YALYALUP Mineral Sands Project

ENVIRONMENTAL REVIEW DOCUMENT- RESPONSE TO SUBMISSIONS, V4

EPA ASSESSMENT NO: 2141

Document Ref: DMS-YAL-ERD-RTS-004-V4

FIGURE 3: YARRAGADEE AQUIFER MODELLED WATER LEVELS

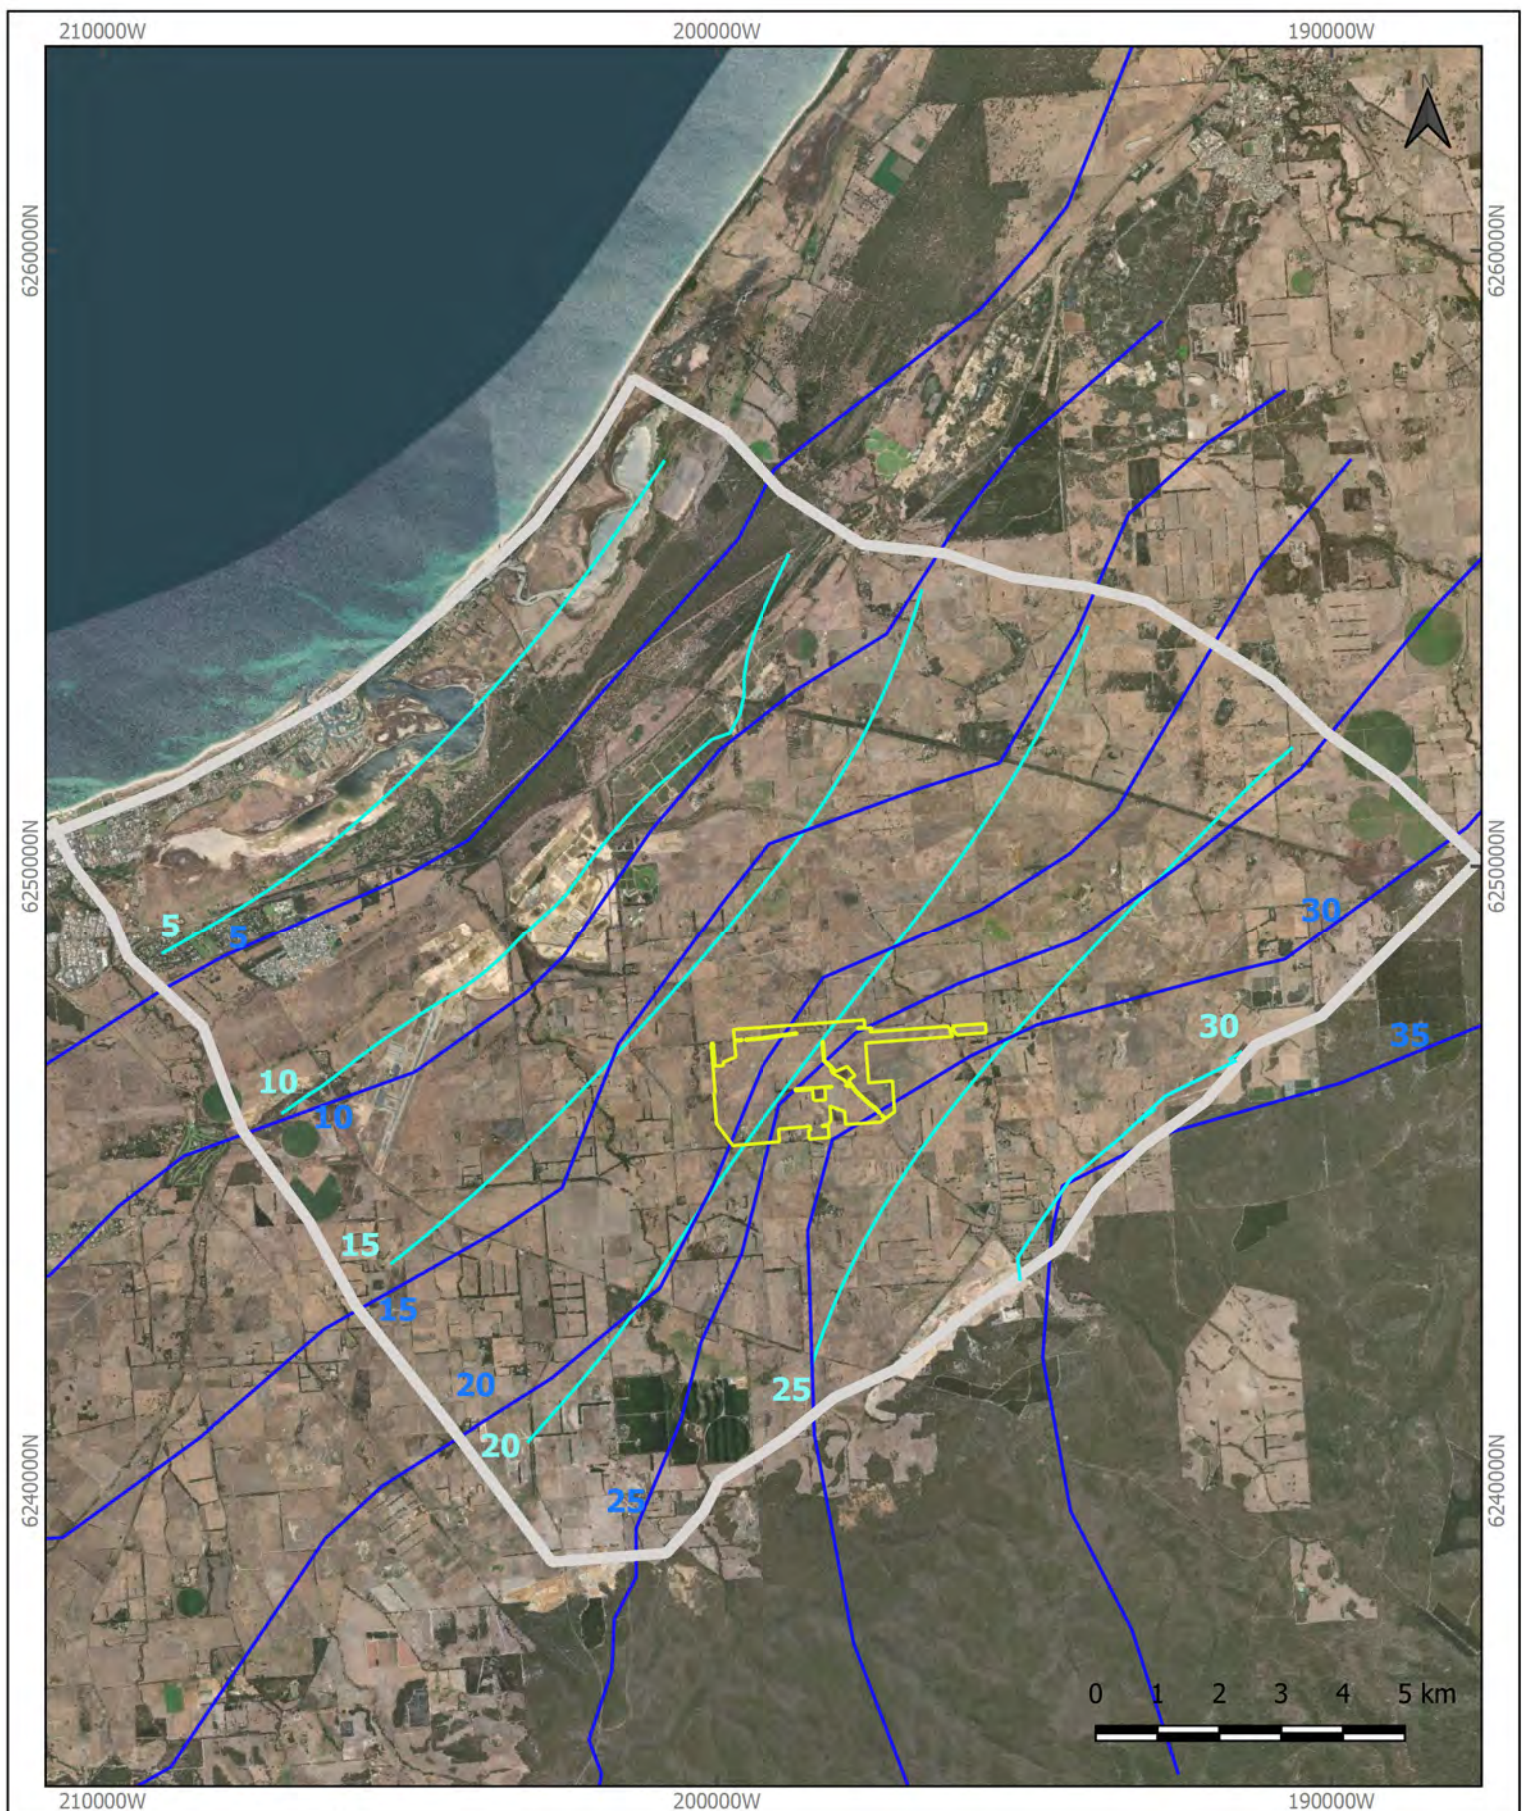
SUBMITTER	SUBMISSION AND/OR ISSUE	RESPONSE TO COMMENT
DAWE	<p>1d. The proponent needs to justify why drawdown of the Yarragadee aquifer is “unlikely to have any adverse impacts on the water supply potentials of the aquifer systems” (ERD, p. 124) given the high degree of model uncertainty and lack of sensitivity analysis.</p> <p>The Yarragadee production bores will only be used to supplement recycled water from the hydraulically returned tailings and dewatering. Pumping from the production bore in the Yarragadee aquifer will only occur during periods of water shortfall (i.e. during summer).</p> <p>The proponent has predicted a peak make-up water demand of 1.3 GL/year to be required from the Yarragadee production bore (to support peak mine water demand of 1.6 GL/year). Additionally, the proponent suggests that a GWL from the Yarragadee of 1.6 GL/year be applied to cover the full mine water demand as a contingency. Pumping from the Yarragadee aquifer will only occur if the total storage volume of the site storage ponds drops below the equivalent of 2 days of supply (nominally 10,000 m3) (AQ2 2020c, p. 11).</p> <p>Not addressed.</p> <p>It is unclear if the Yarragadee aquifer has been calibrated in the groundwater model. For example, the AQ2 memo states that “<i>there is no data available for model calibration for the Yarragadee aquifer</i>” (AQ2 2020e, p. 3), yet the Hydrological Assessment states “<i>locations of monitoring bores screened in the Leederville and Yarragadee aquifers and used for model calibration, are shown in Figure 45</i>” (AQ2 2020a, Appendix F, p. 1). Figure 45 identifies a single monitoring bore (61000125) screened within the Yarragadee aquifer used for groundwater model calibration. Use of a single bore for calibration is grossly inadequate.</p>	<p>The modelling completed used the available information to define the geometry and assign conservative aquifer parameters to the Yarragadee aquifer. This included data from the SWAMS regional aquifer modelling and published data to define aquifer geometry and parameters (refer to Tables 1 to 5, Attachment 2).</p> <p>The model was calibrated to available water level monitoring for the Yarragadee aquifer (water levels from 61000125) and also simulates water level contours for the Yarragadee aquifer simulated by the SWAMS model (refer to attached Figure 3 showing contours of modelled water levels from the SWAMS model and modelled water levels for the Yarragadee aquifer, which show consistent water level magnitude and flow direction).</p> <p>There are no other data publicly available in the study area, apart from that used for model calibration. There are some Yarragadee monitoring bores located upstream and downstream of the Proposal area that are located close to the model boundaries, however their proximity to model boundaries mean that they were not suitable for model calibration. It is also understood that there is some other regional monitoring available from nearby Yarragadee aquifer users, however this data is not publicly available.</p> <p>The model simulation of available monitoring data is criticised for its match to available data. The Yarragadee monitoring bore that is used for the model calibration (61000125) is screened over 20m of the Yarragadee aquifer (to target Unit 3 only), whereas the groundwater model simulates the Yarragadee aquifer as a single aquifer unit/layer. There are also uncertainties in the actual abstraction rates included in the model calibration (only licenced allocations are available for groundwater use in the modelled catchment). Rather than force model calibration, to limited available data, the model set up was kept consistent with suitably conservative aquifer parameters for the Yarragadee aquifer. This approach was taken to provide conservatism in the model predictions. While there is</p>

SUBMITTER	SUBMISSION AND/OR ISSUE	RESPONSE TO COMMENT
	<p>Furthermore, a hydrograph for this bore is provided but is poorly matched to the modelled water levels (AQ2 2020a, p. 37). The measured water responses from this bore are generally between five and six metres below the modelled water levels (AQ2 2020a, Figure 65). The proponent suggests this poor history matching is a result of groundwater pumping that is not reflected in the modelled abstraction rates (AQ2 2020a, p. 37). The Department therefore has limited confidence in the predicted impacts (e.g. magnitude and extent of groundwater drawdown) for this aquifer.</p> <p>Additionally, it is unclear if the proponent has conducted a sensitivity analysis for the Yarragadee aquifer. Table F1 (AQ2 2020a, Appendix F, p. 4) indicates both the base and uncertainty case scenarios have identical parameters, yet the proponent states that Yarragadee aquifer conductivity values (both horizontal and vertical) were reduced by half as part of the model calibration sensitivity analysis which did not significantly impact the model calibration performance (AQ2 2020a, p. 40). The proponent needs to clarify this discrepancy.</p>	<p>still acknowledged uncertainty around the predicted impact of water supply pumping it is unlikely to have any adverse impact on the water supply potential of the Yarragadee aquifer.</p> <p>Moreover, the closest licenced Yarragadee aquifer production bore is located at 4.5km from Doral's proposed Yarragadee production bore. Small drawdowns (between 0.25 and 0.5 m) are predicted at the closest licenced Yarragadee aquifer production bore (provided Doral's proposed production bore is pumped continuously at 1.6 GL/year for the duration of the mine life). The conservative approach, that included the maximum abstraction from Doral's proposed bore was used to predict the "worst case" for impacts on the aquifer water supply potential. Doral plan to abstract from the Yarragadee aquifer bore only when required, which will most likely only be during summer periods when there is a shortfall of water supplied from rainfall runoff and pit dewatering (from the Superficial aquifer). During winter reduced to no pumping from the production bore will occur, and the actual drawdown in the Yarragadee aquifer will be smaller than predicted. Additionally, it should be noted that there is generally 4 to 5 m of the average seasonal water level fluctuation in the Yarragadee aquifer evident at the study area, with a gradual declining trend associated with ongoing pumping activity in the area.</p> <p>As part of the installation of Doral's Yarragadee water supply bore, and submission of an application to DWER to obtain an operational licence for water supply pumping from the Yarragadee, the following work is planned:</p> <ul style="list-style-type: none"> • The model set up for the Yarragadee aquifer will be refined based on the information obtained from the drilling and testing of Doral's water supply bore. • If required, the Yarragadee aquifer will be simulated by several layers.

SUBMITTER	SUBMISSION AND/OR ISSUE	RESPONSE TO COMMENT
		<ul style="list-style-type: none"> • The model calibration will be updated and model simulations to predict the impact of the Yarragadee pumping will be completed. • Uncertainty analysis will be completed to assess a range of potential impacts from the proposed water supply pumping. <p>As part of the model calibration process, model parameters were changed and the impact on the model calibration performance was observed. During model calibration, the horizontal and vertical hydraulic conductivity of the Yarragadee aquifer was halved and was not observed to have an impact on the model calibration performance. Similarly, increasing the vertical hydraulic conductivity of the Vasse member of the Leederville aquifer was not observed to have an impact on the model calibration performance. For the uncertainty modelling, however, aquifer parameters were changed and the model was re-calibrated to provide the best match to observed water levels. As part of this process, no changes were made to the aquifer parameters for either the Leederville or Yarragadee aquifers. Please refer to DAWE comment 1b above in regard to the additional model run (i.e. September 2020 case, Attachment 2).</p>
